CALIFORNIA COASTAL COMMISSION

REGULAR CALENDAR
STAFF REPORT AND PRELIMINARY RECOMMENDATION

Application No.: 6-99-43

Description: Subdivision of approximately 7.8 acres of vacant land into 20 lots and construction of 42, two-story, three-bedroom condominium units, with associated private interior streets and driveways, utility connections, landscaping, private gated entry and a public trail on the north shore of Agua Hedionda Lagoon. Also proposed are off-site improvements to Bayshore and Marina Drives and enhancement of existing wetlands on-site.

EXHIBIT NO. 3
Application No. 6-99-43
Results of 8/25/99
Field Survey by
Applicants' Biologist

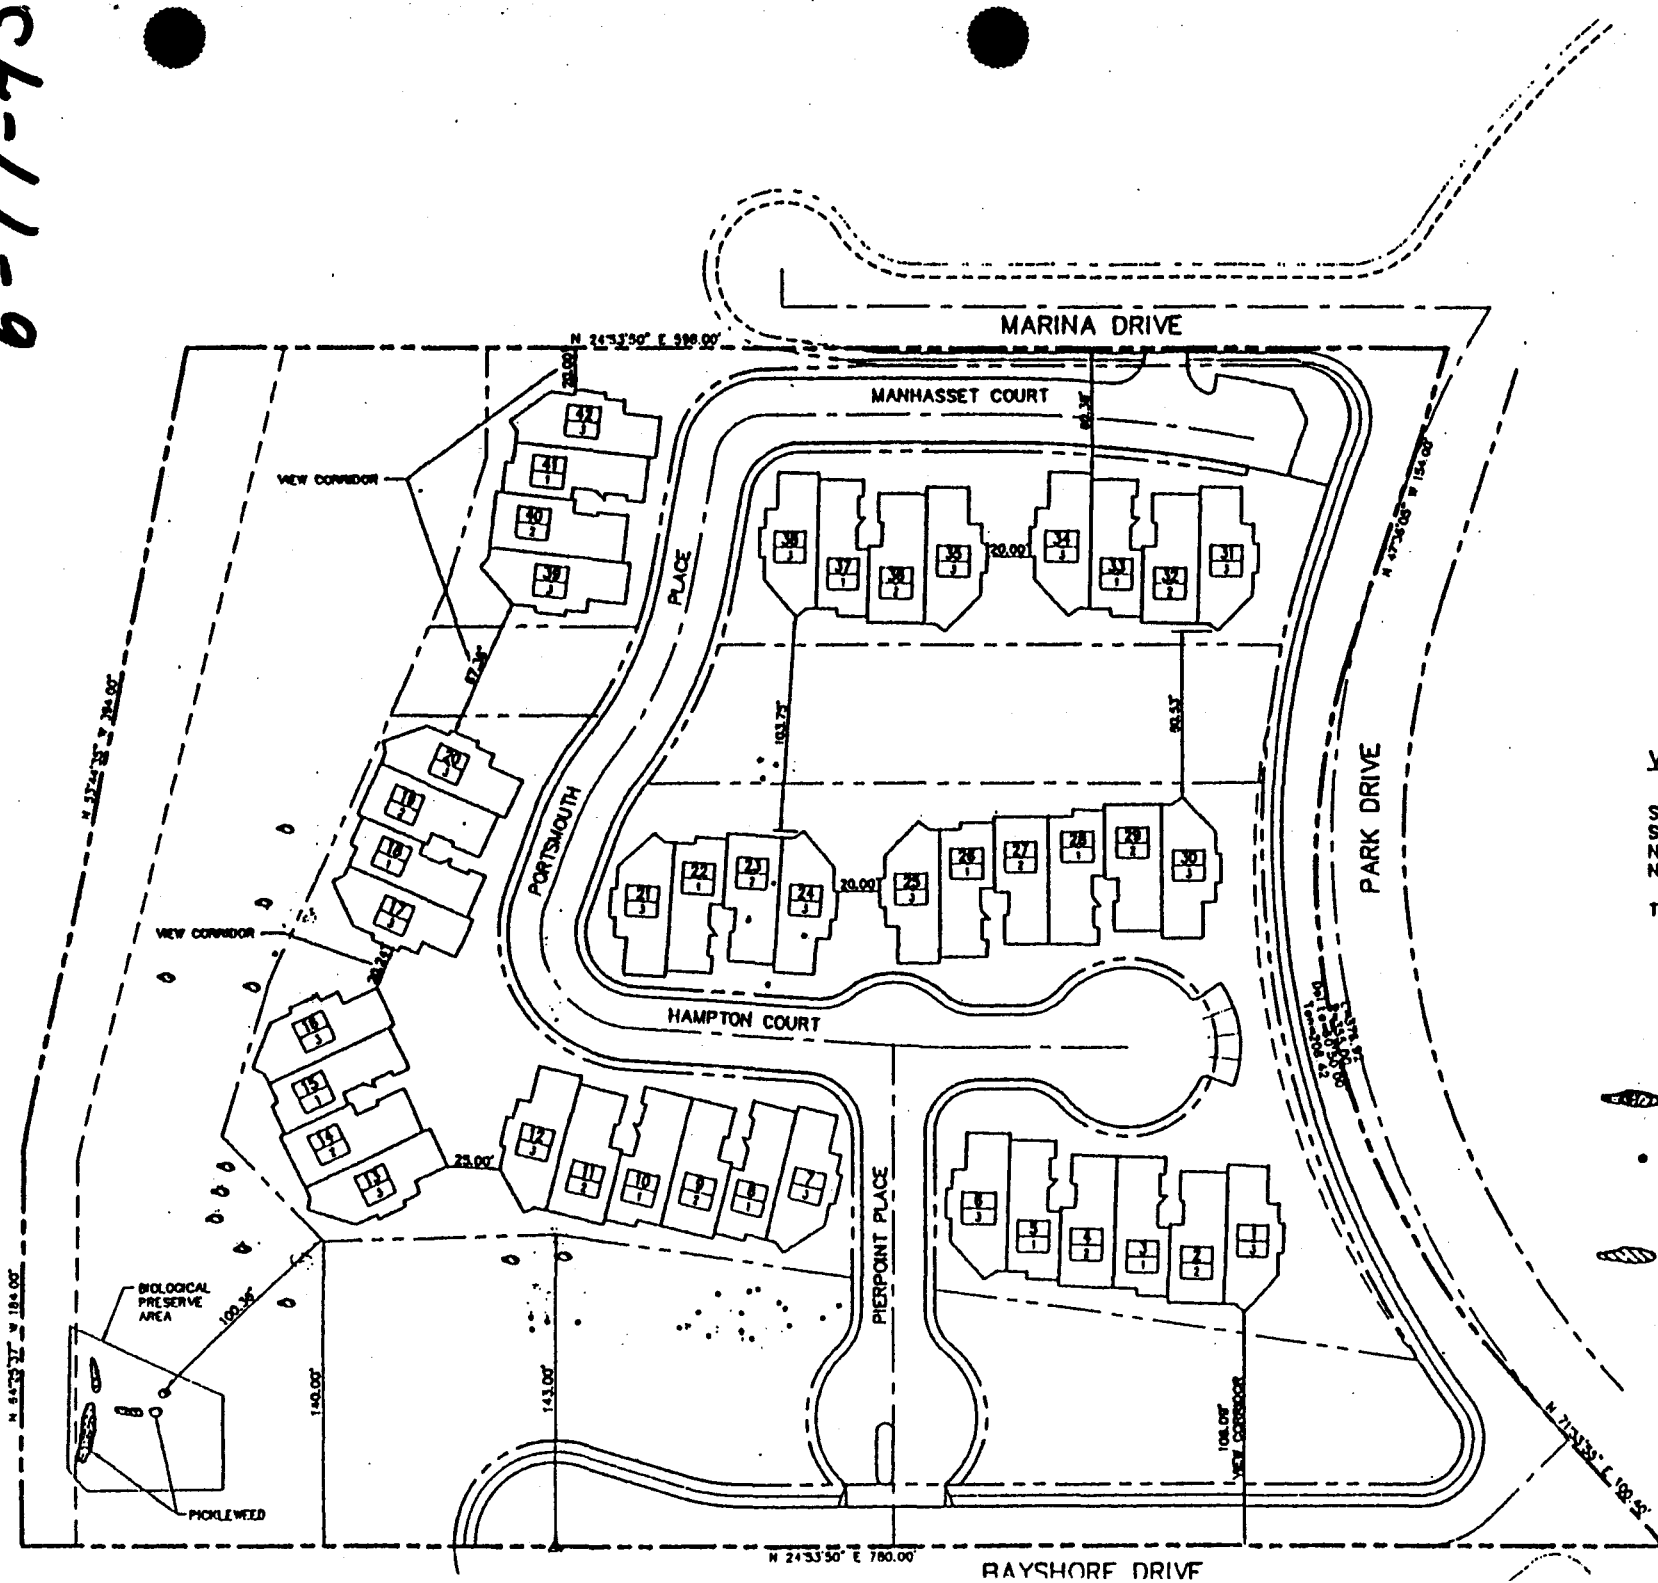
- a. there shall be a minimum 100-foot buffer between all delineated wetlands, as depicted on Exhibit #3, including seasonal ponds or vernal pools, and all proposed site improvements, including grading, with the exception of the proposed public walkway, which may be placed in the upper (landward) half of the buffer;

"depressions" shown on the updated project plan submitted on August 25th (Exhibit #3) are located in relatively close proximity to proposed development, within the 100-foot area that would typically be required for buffer purposes. In addition, the grading plans submitted with the application indicate that site grading would occur within twenty feet of the identified salt marsh vegetation in the southeastern corner of the site and within the erosional feature itself.

In imposing these conditions, the Commission finds that the subject site is severely constrained by existing visual, biological and access resources which require protection under the Coastal Act. In redesigning the project to accommodate a 100-foot buffer from all wetlands, including the seasonal ponds, it is likely the applicant will have met the stringline requirement as well. This projection is based on the site plan most recently submitted to the Commission, which is included as Exhibit #3.
